Project Name: **Marlboro BRF 010-1(43)**
Structure Identification: **Bridge #48 on VT RTE 9 over Whetstone Brook**

The Temporary Bridge and detour plans received in this office on January 14, 2014 have been reviewed. Please address the comments below and resubmit the plans.

Vermont Agency of Transportation
RECEIVED
Marlboro BRF 010-1(43) Temp Bridge Resub 1-16-2014.pdf
CK'D BY RK OK'D BY JS
January 14, 2014
RESUBMIT YES Rejected
BY KH DATE 1-16-2014

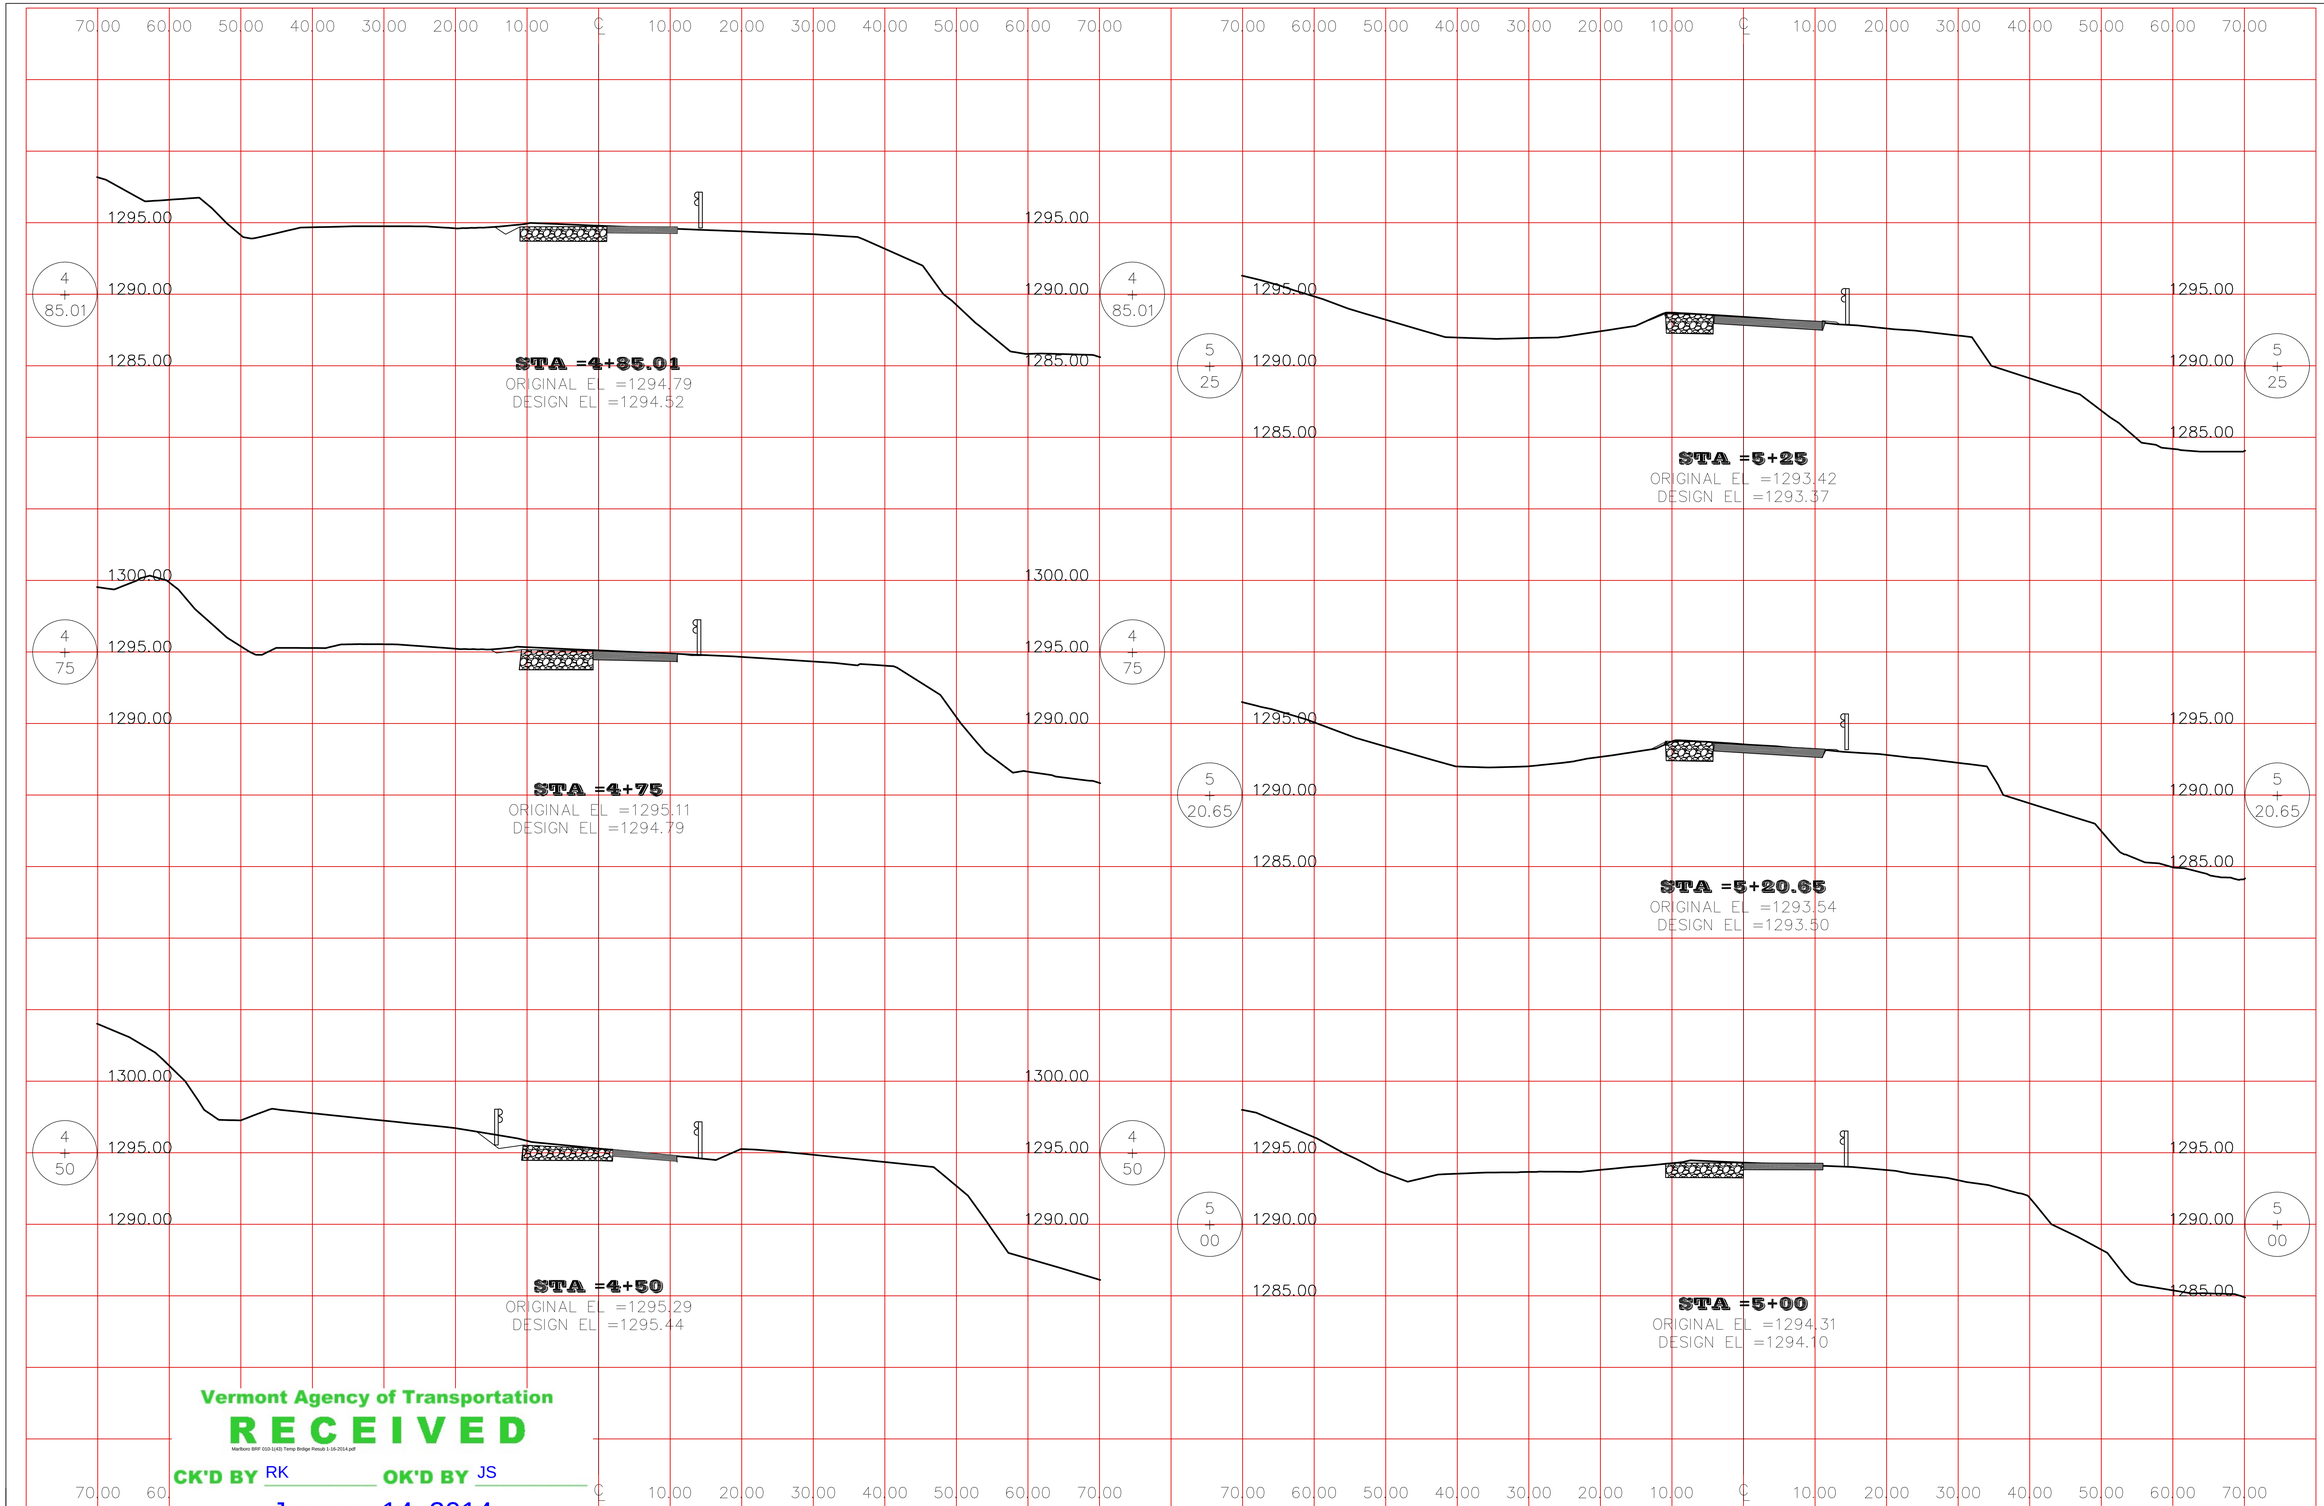
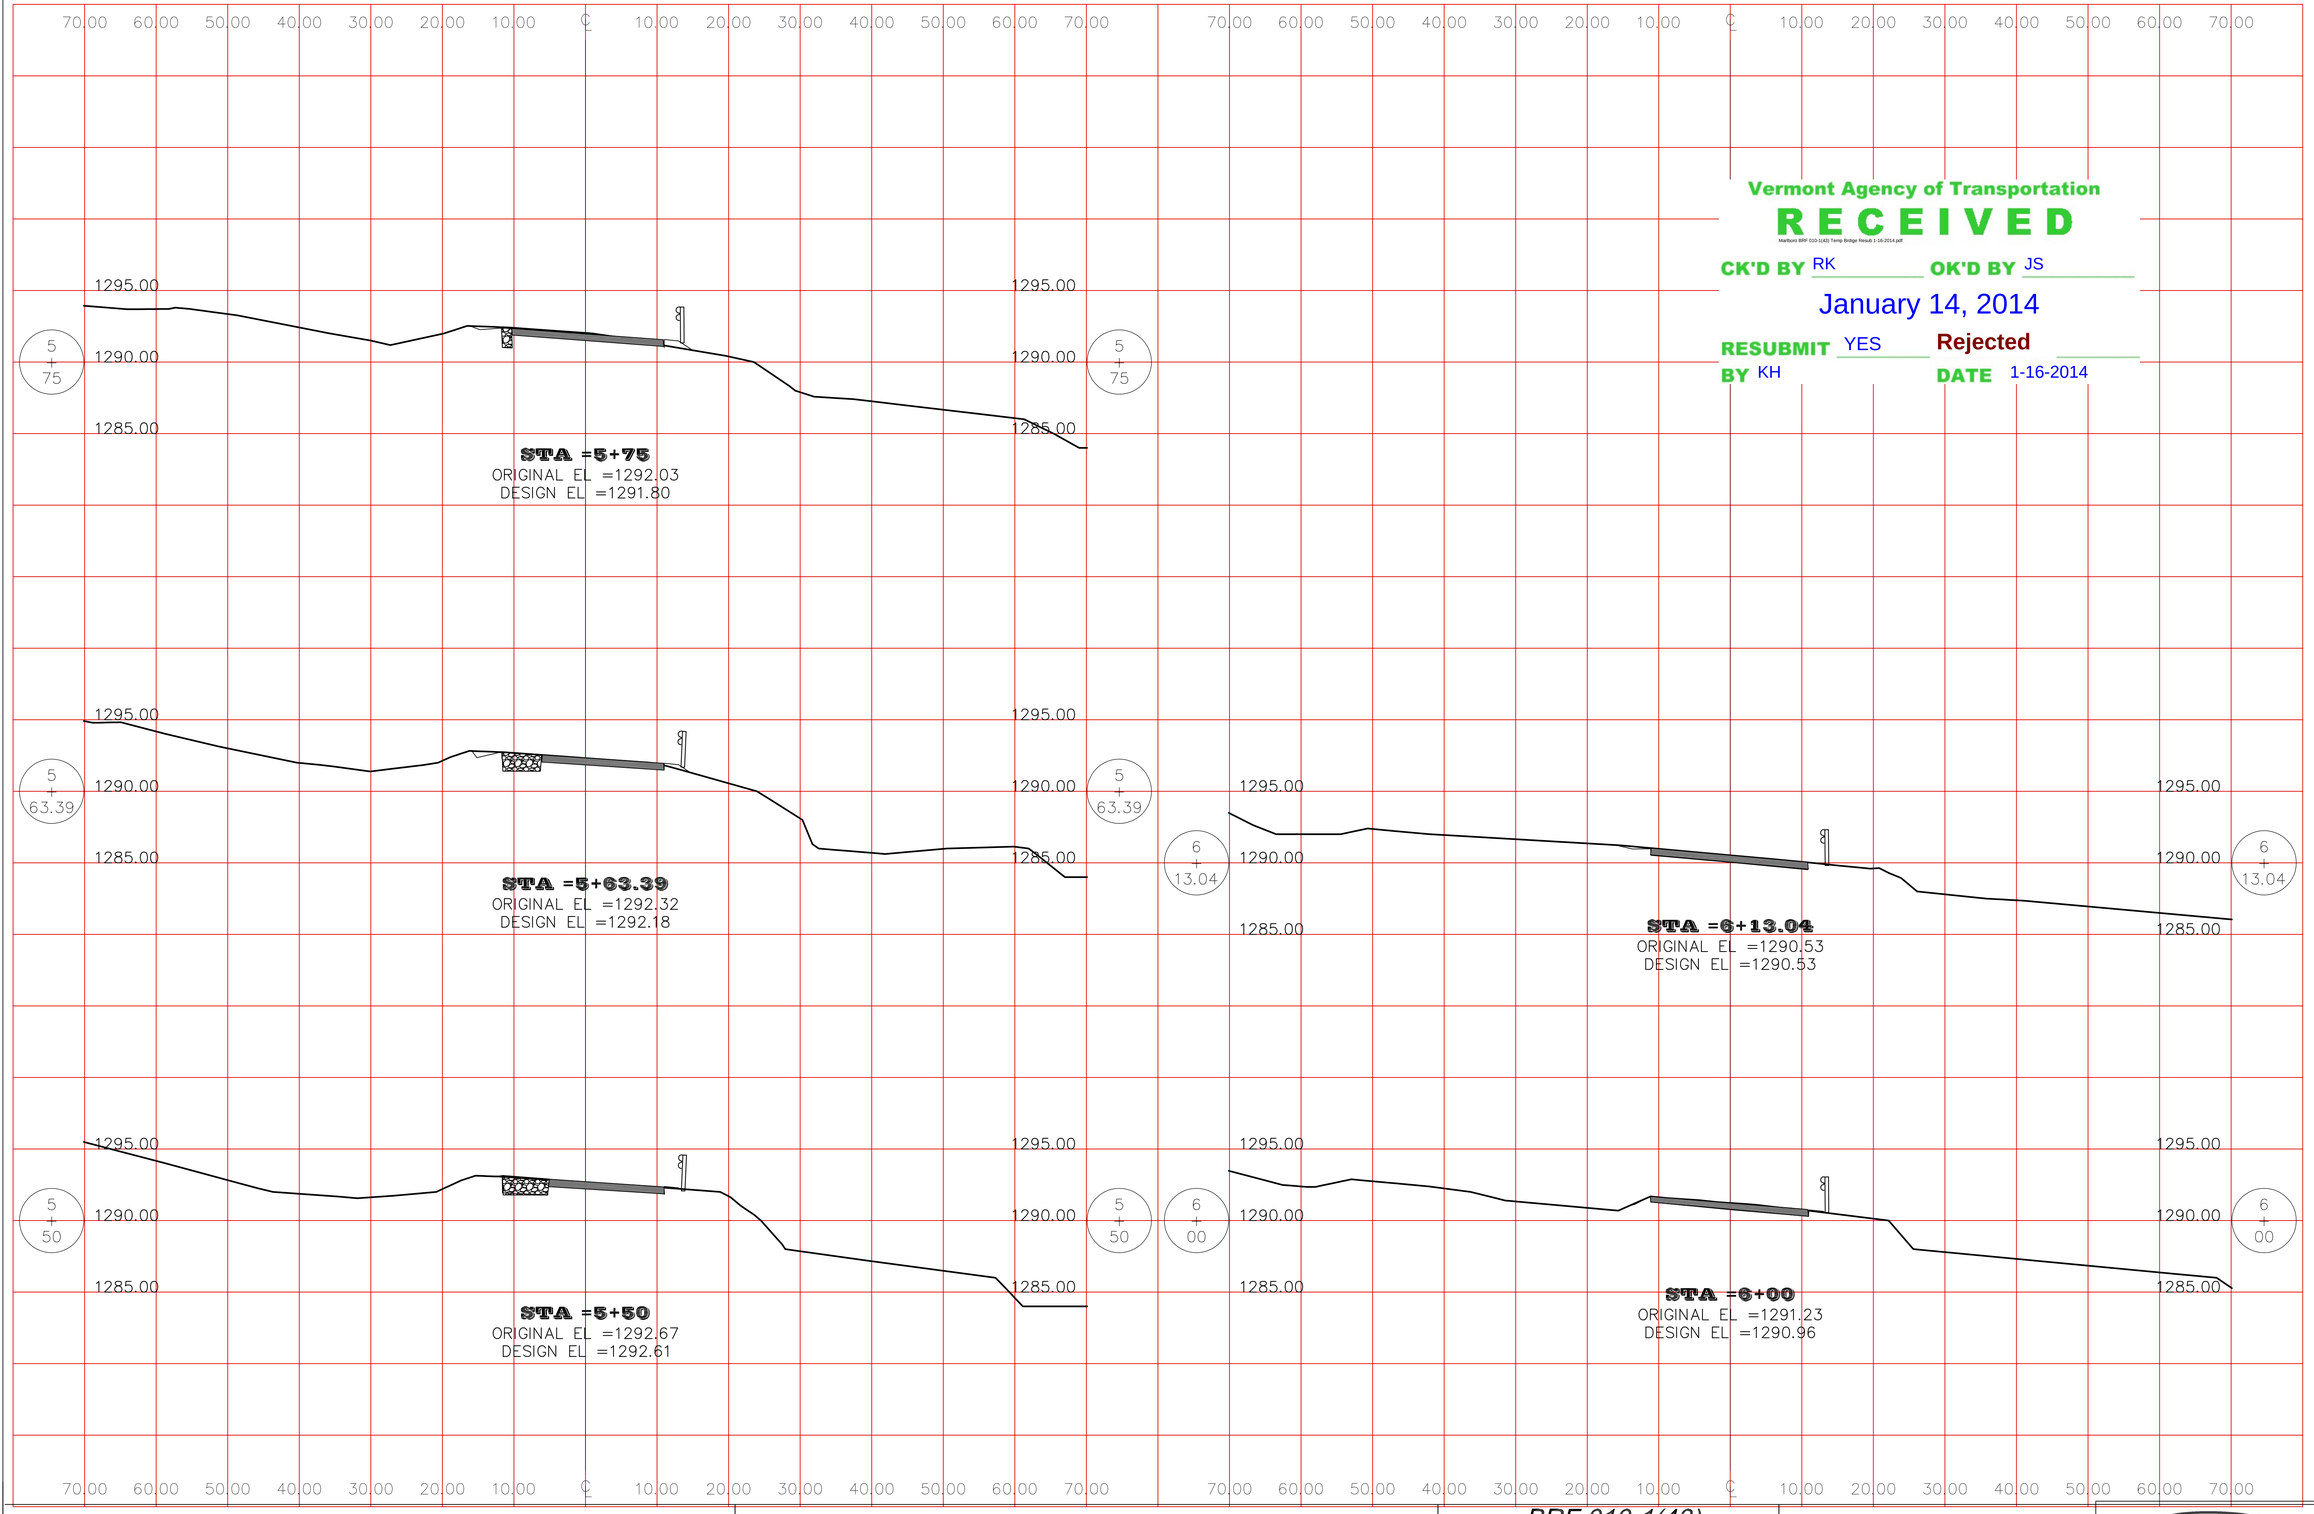
4. Cross Sections:
    a. Sections 1+50 through 2+50 are missing. Page 5 of 9 was duplicated in submittal, missing page 4 of 9?
    b. Show existing girder(s) that will be used for temporary bridge on sections.

c. Show portion of existing bridge deck that will be retained for temporary bridge on sections.
    d. Show roadway cross slope.
